Covering Note - Response to NatureScot Points (a) and (b) – River Moriston SAC

1.1 On 19 January 2026, NatureScot submitted a further updated consultation response in respect of the application for section 36 consent and deemed planning permission for the Glen Earrach Pumped Storage Hydro Scheme (the 'Application'). The NatureScot response related specifically to impacts on the River Moriston Special Area of Conservation ('SAC'). It identified five areas on which NatureScot wished to receive further information listed as items (a) to (e) relating to the SAC.

Appendix A – Responses to Points Raised by NatureScot in its Response of 25 February 2026

03 Phase 3 - Form New Variable Weir
0103 NTS

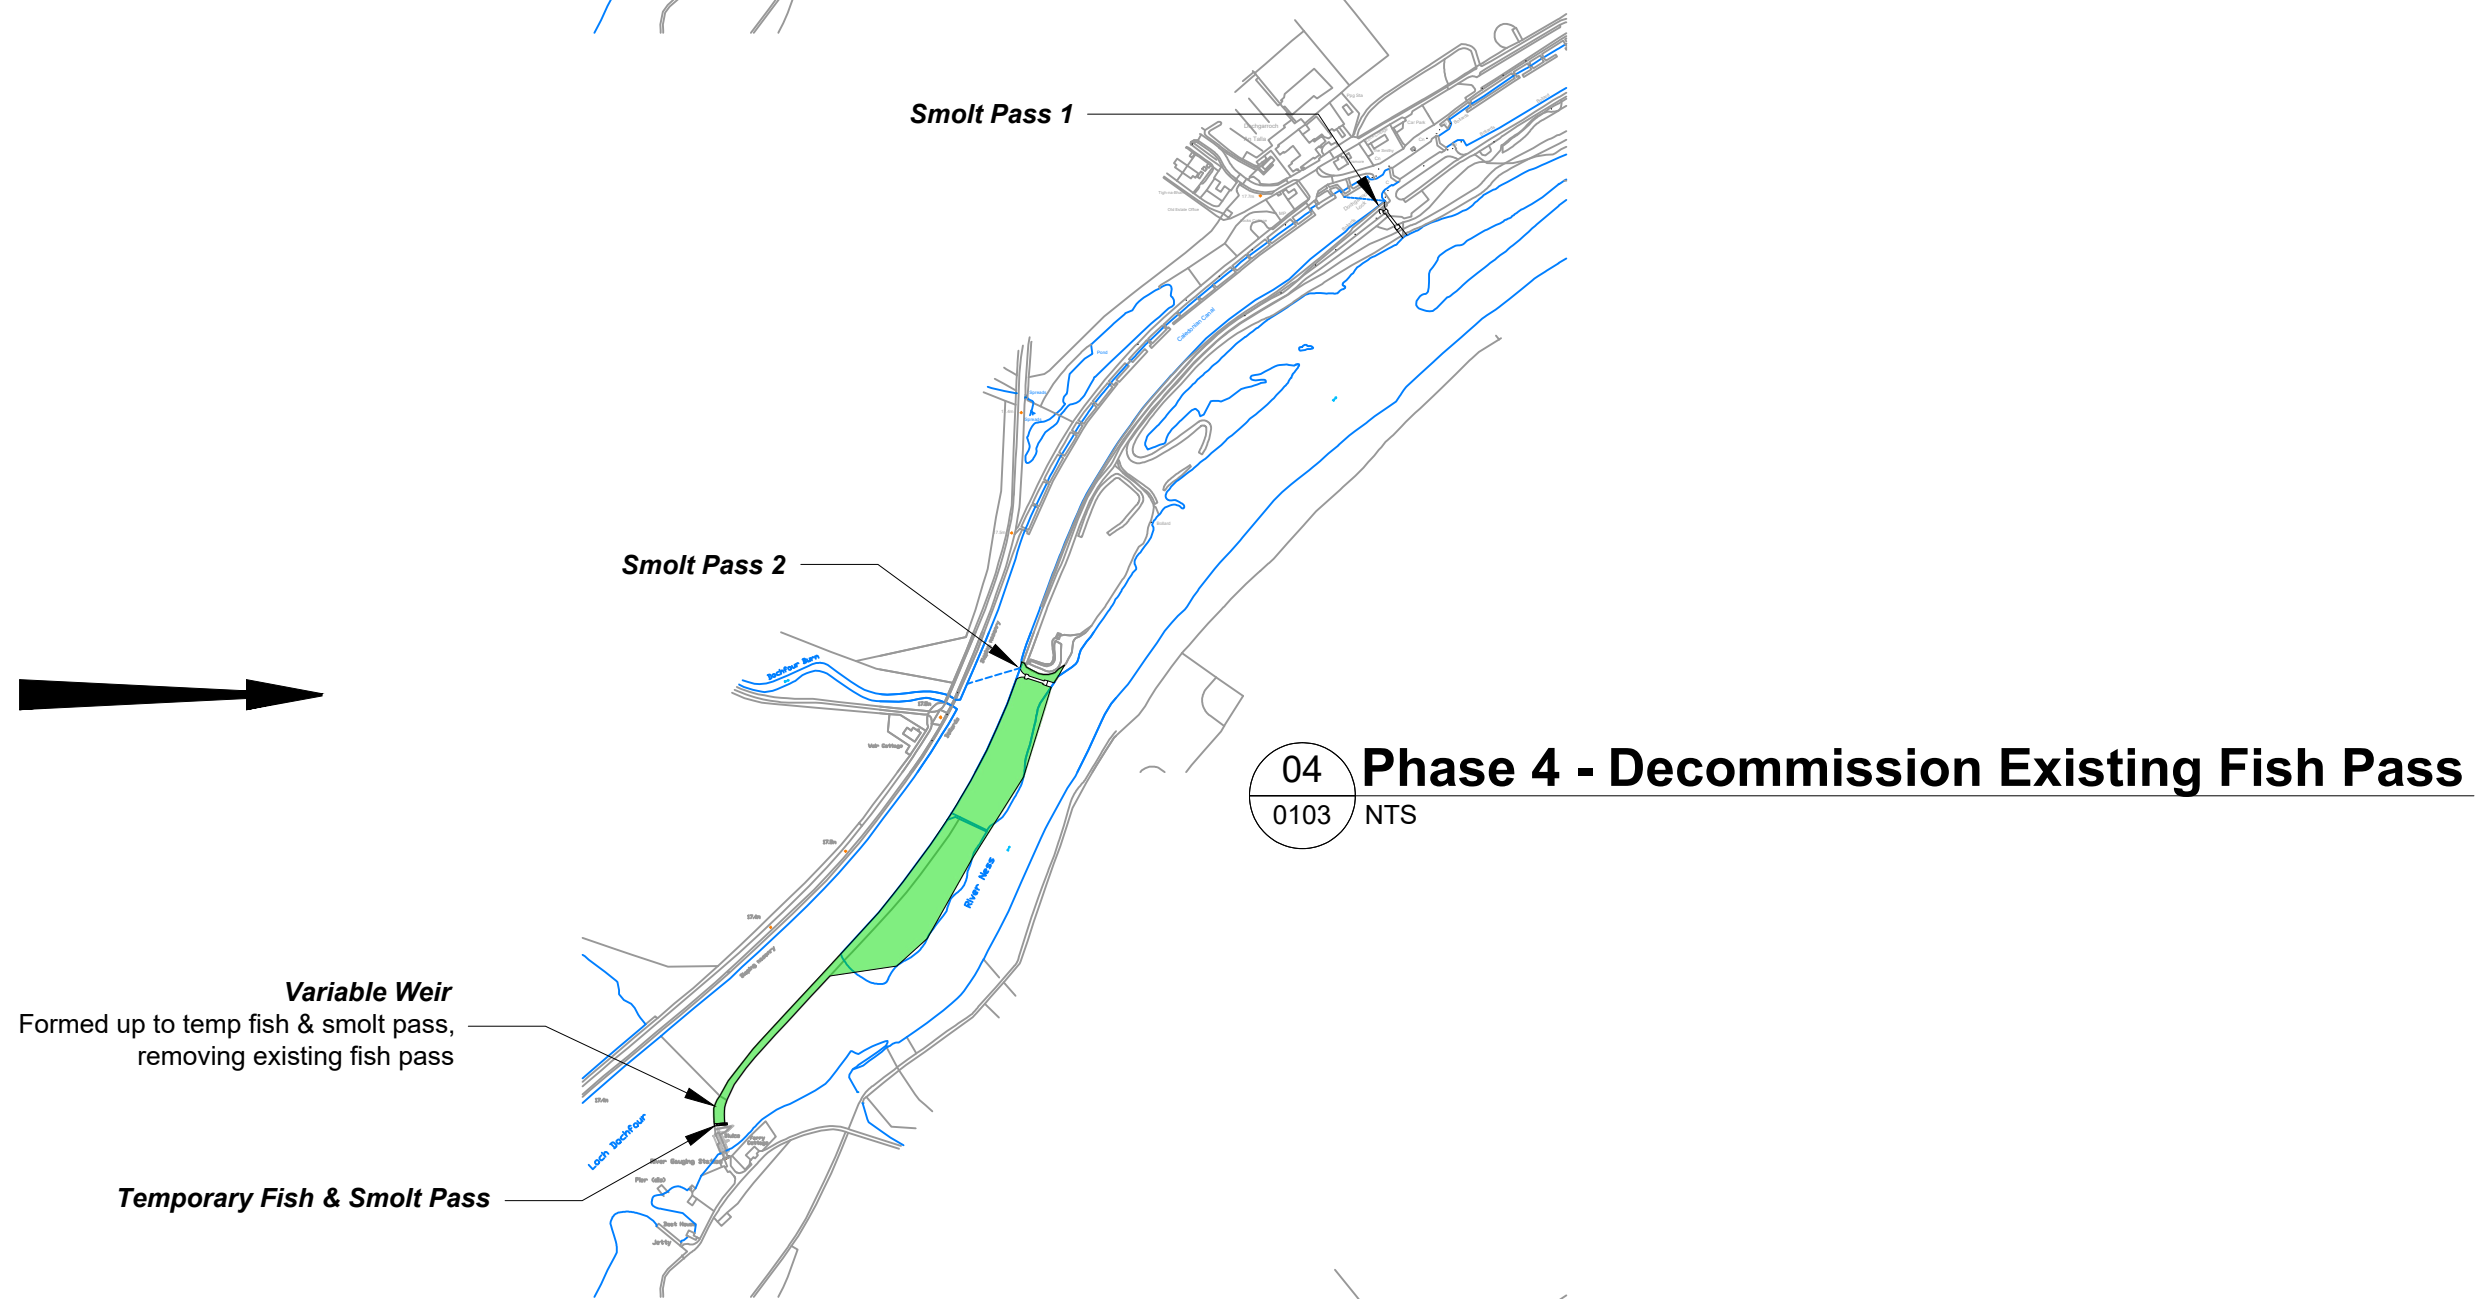
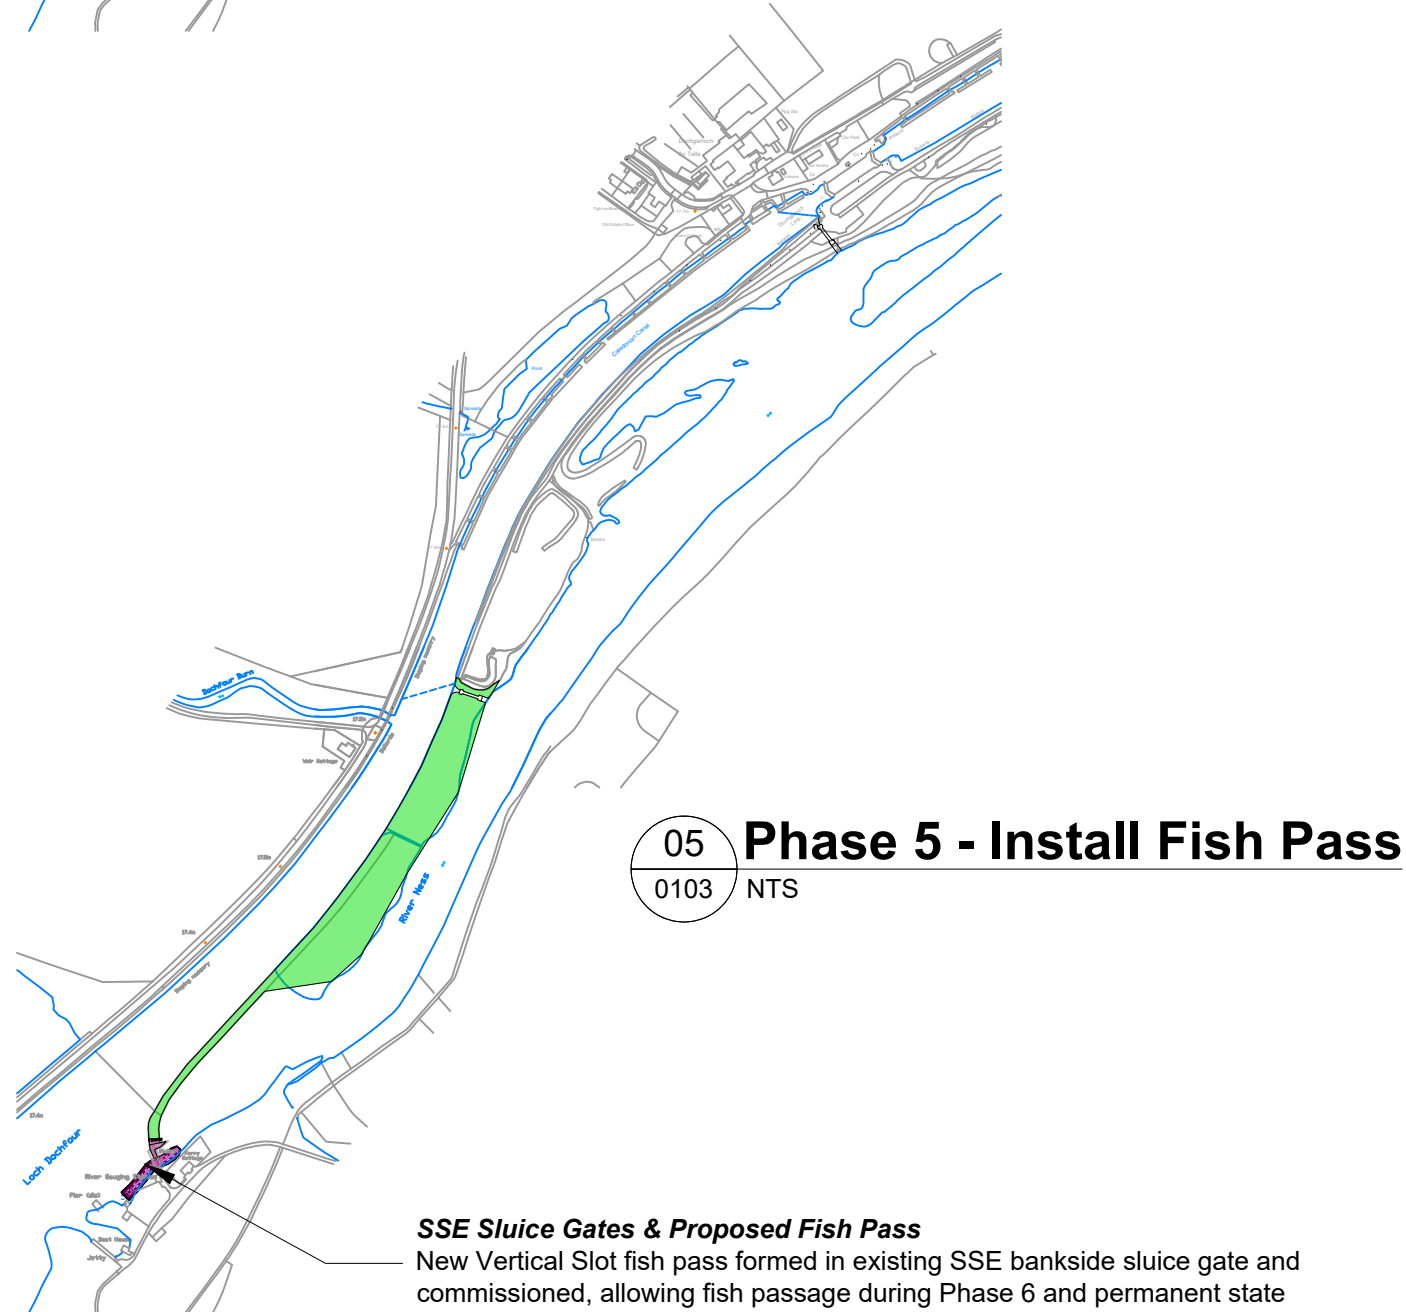
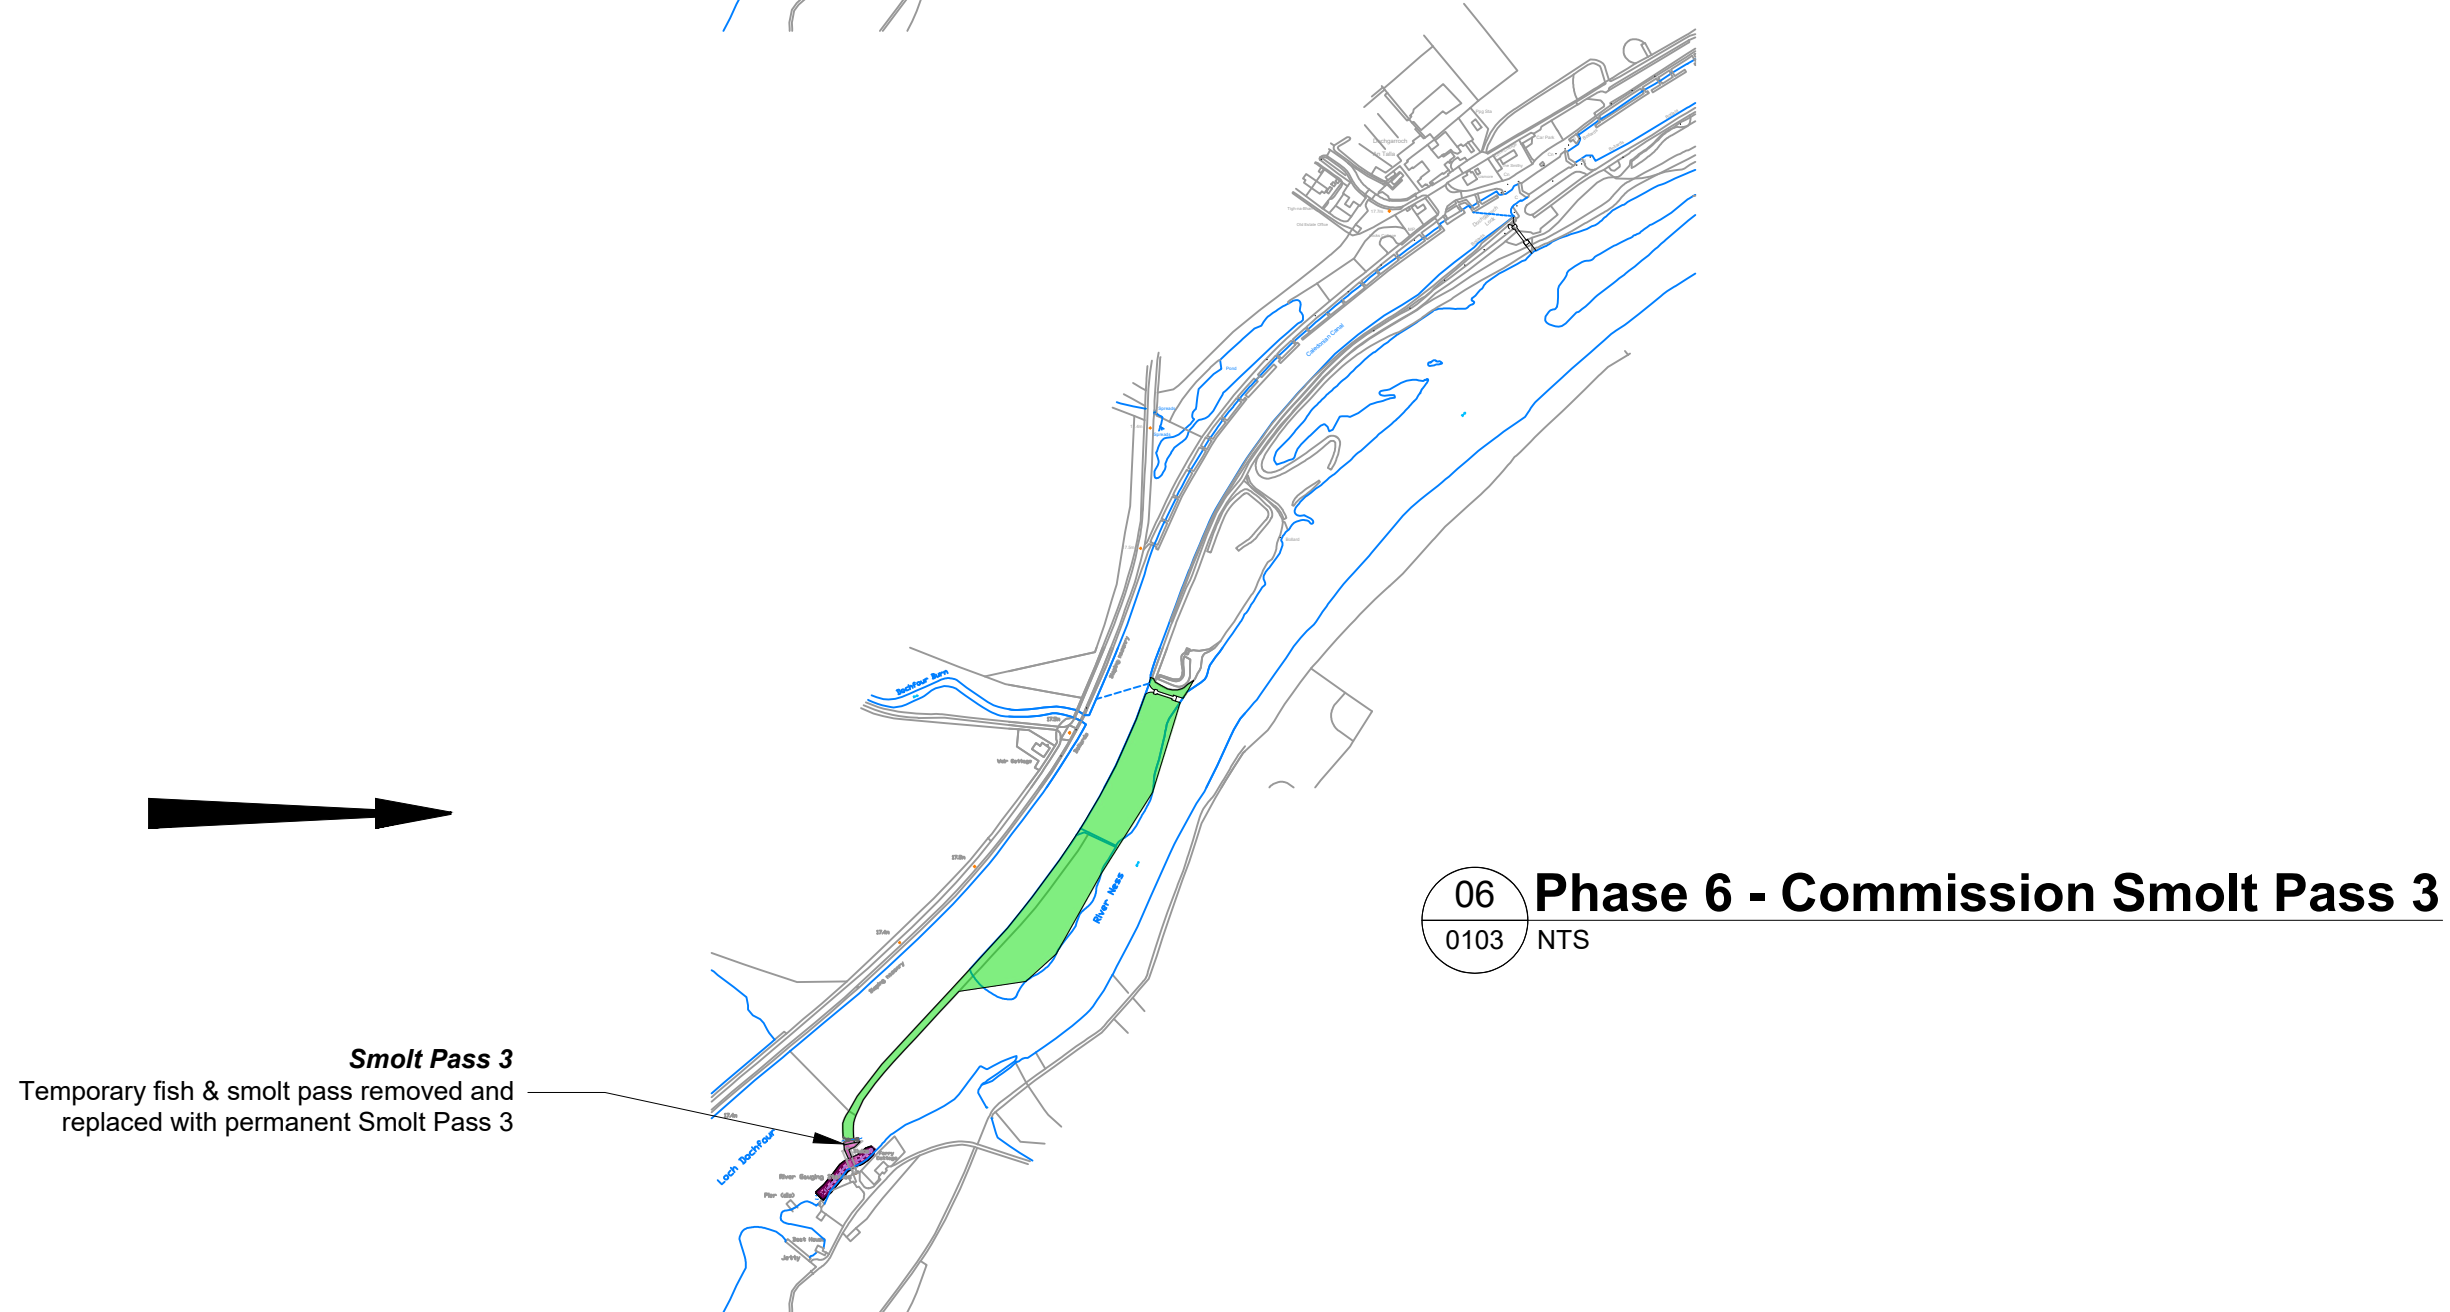
- to demonstrate that the proposed temporary Alaskan Denil pass will be passable by Atlantic salmon throughout the construction period. Evidence should explicitly draw on published guidance and research to detail each parameter (eg attractant flows, velocities, water depths) that needs to be considered in the design to ensure salmon passage; the range of values the fish pass will be designed to deliver for each parameter; and justify why these have been selected in relation to those recommended in the literature.

Applicant response: Temporary Fish Passage Technical Note v1.3 now includes further detail on the flow volumes and hydraulic operation of the temporary fish passage elements. The construction sequencing drawing 0103-3540681-P03 now includes clear detail how upstream and downstream passage will be maintained through the construction phase. The continuity of passage is also described in detail in the specific note Construction Disturbance and Fish Passage Continuity at Dochfour Weir.
